ADDENDUM NO. 10
August 16, 2019

PARKING STRUCTURE 1
PROJECT NO. 956553

| Project UC RIVERSIDE PARKING STRUCTURE 1 (956553) | | Intelligent Design & Process Management | Dwg. No. SK-E1 |

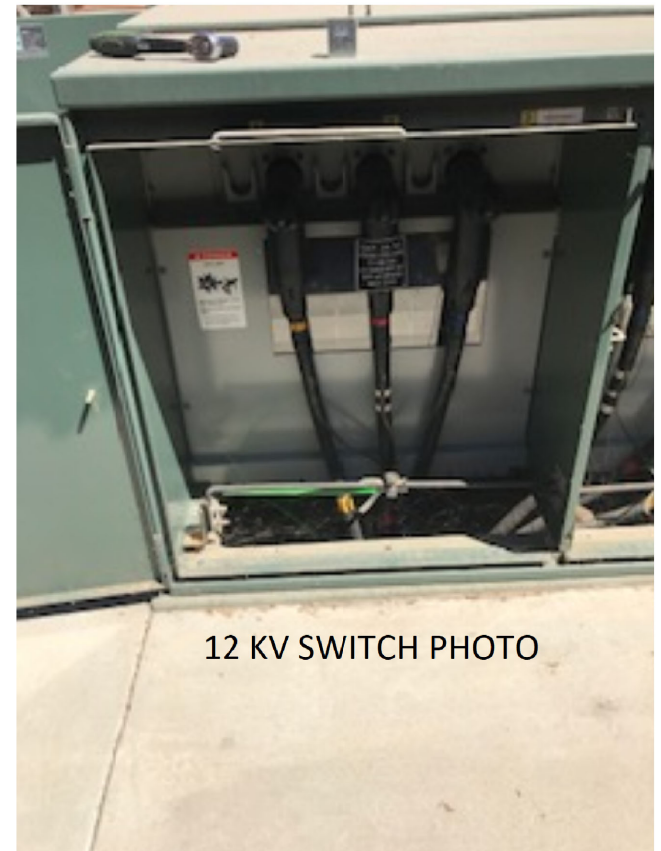
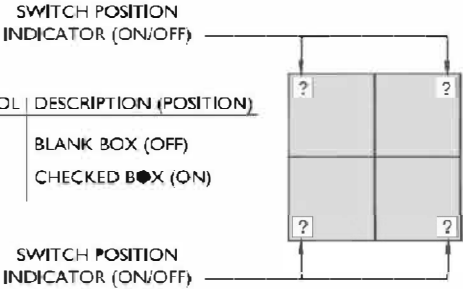
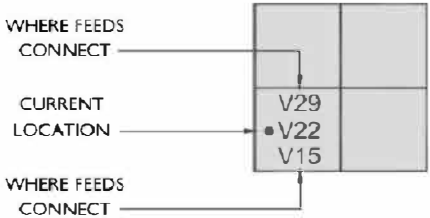
| Q80 | Addendum #8 Q&A 33 tells us that the 12kv point of connection is in electrical vault 15c located on the north side of Big Springs Road. What are we tying into in this vault? Is there an existing 12kv switch or are we splicing to an existing 12kv feeder? |

| Q94 | Under University Furnished Information page 1 of 8 item 2B UC Riverside Glen Mor 2 Electrical Distribution Extension, David Beckwith and Associates. This is a Civil drawing for wet utilities. Please issue the correct Electrical Distribution plan. |

| A80 | Connection will be to a switch. Refer to University Furnished Information, Item 2.H for additional information, which is issued in this addendum. |

| | An additional Electrical Distribution Plan (SK-E1 Electrical Distribution Schematic) is furnished as University Furnished Information, which is issued in this addendum. |
